A428 Black Cat to Caxton Gibbet improvements

9.82 Flood Risk Assessment Technical Note

**9.82 Flood Risk Assessment
Technical Note**

1.1.1 The purpose of this Technical Note is to address the clarification requests made by the Environment Agency (EA) after the submission of the A428 Flood Risk Assessment [APP-220] and associated Annex B: Ordinary Watercourse Modelling Report [APP-222]. This Technical Note is to be an Addendum to the FRA [APP-220]. In addition, clarification is provided regarding groundwater modelling as requested in the EA Deadline 4 submission – responses to the ExA's Second Written Question (WQ2) [REP4-068].

Figure 4-1: Sensitivity Analysis of A428 Culvert for the 1% AEP + 65% CCA Event for Begwary Brook Model

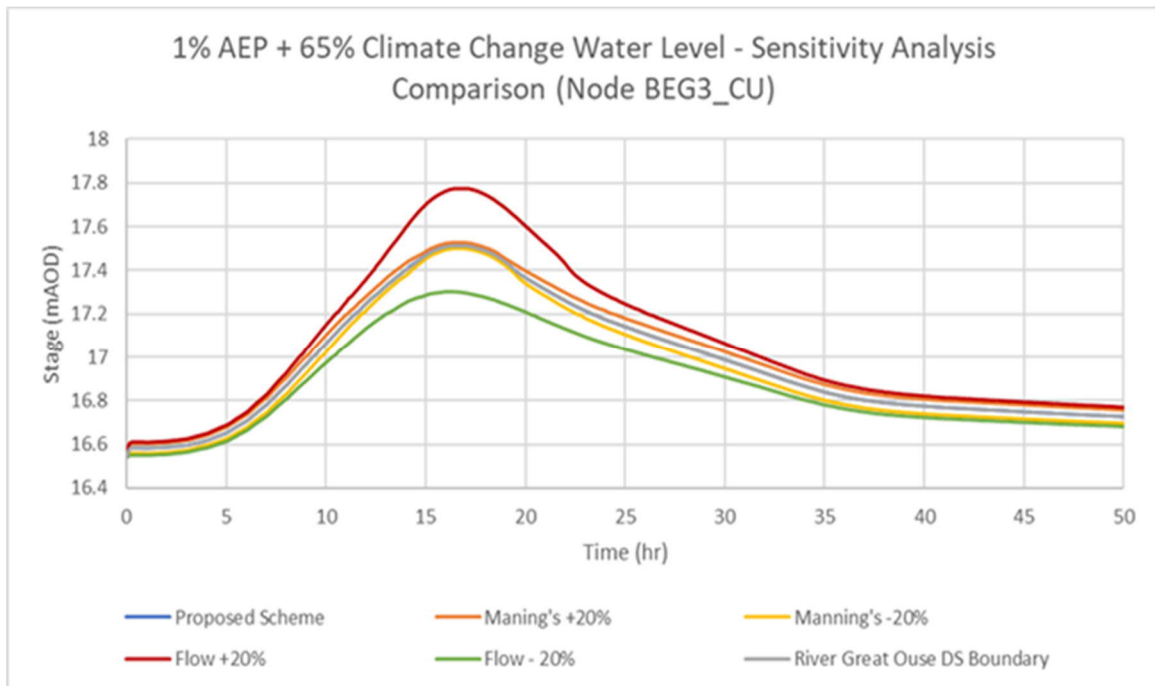
- 4.1.4 The results of the sensitivity test show a 20% increase in flow at the upstream boundary has produced an increase of 0.26m in the maximum water level at the proposed Roxton Link Road culvert, within the Begwary Brook catchment. When the flow is decreased by 20%, the maximum water level at the proposed Roxton Link Road culvert falls by -0.21m. This response is within the expected range for the sensitivity test undertaken and is not likely to impact any flood risk receptors'

- 4.1.5 The soffit level of the proposed Roxton Road Link culvert is 18.06m providing a freeboard of 0.29m when applying the maximum 20% sensitivity flow increase. It is therefore considered that the sizing of the proposed culverts is appropriate given the sensitivity increase in level associated with a 20% increase in flow to the 1% AEP + 65% CCA event.
- 4.1.6 **Figure 4-1** below provides the previous figure within [APP-222] updated to reflect the sensitivity testing undertaken and reported in **Table 4-1** above:

Figure 8-7 indicating water level change with 20% sensitivity tests

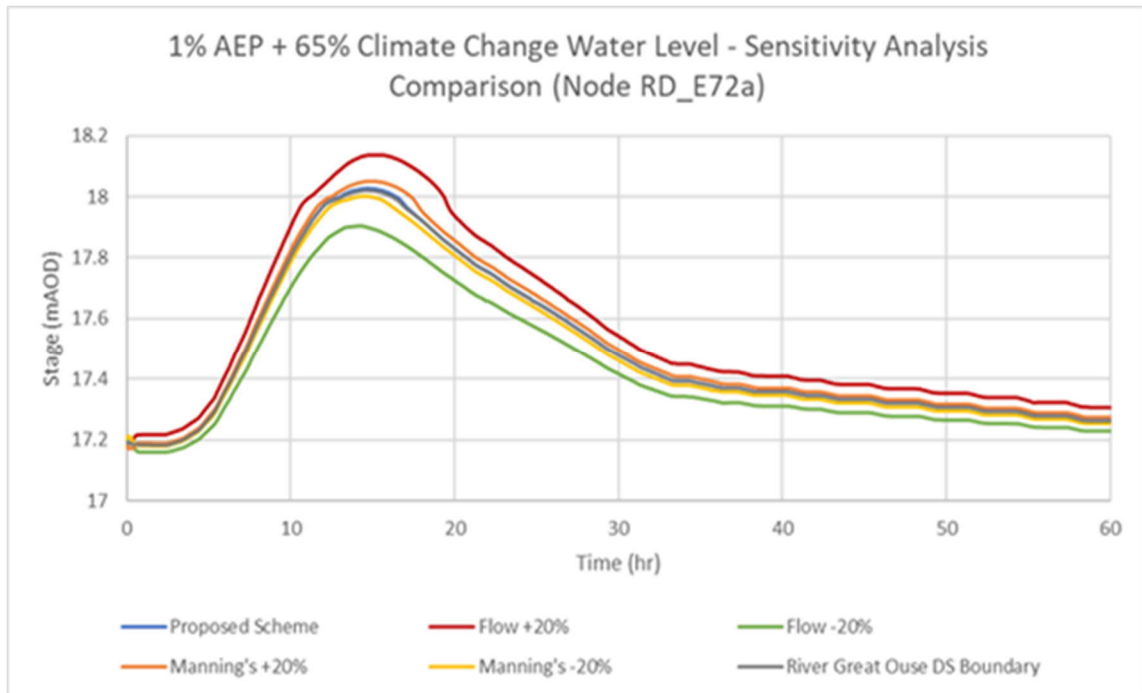
- 6.1.3 **Figure 8-7**, also reproduced from [APP-222] and updated below, shows that the sensitivity testing has no significant impact on the Scheme culverts and is not likely to impact any flood risk receptors, as indicated in **Table 8-3** above.

Figure 10-9: Flow (1D and 2D Combined) Hydrograph

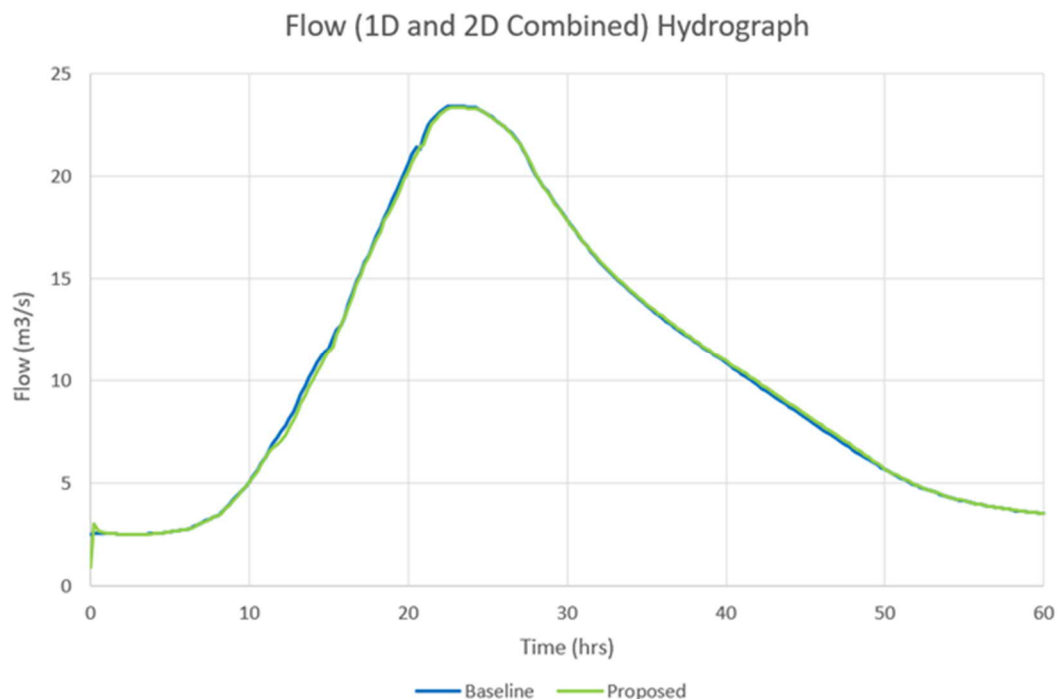
7.1.8 **Figure 10-9** below updates the same figure within [APP-222] to reflect the additional modelling results.

- 7.1.9 In the proposed scenario the maximum water level within the culvert for the 1% AEP + 65% climate change event is 18.82m AOD. The soffit level for this culvert is 22.42m AOD, indicating that there is sufficient freeboard during this event and no further mitigation is required.
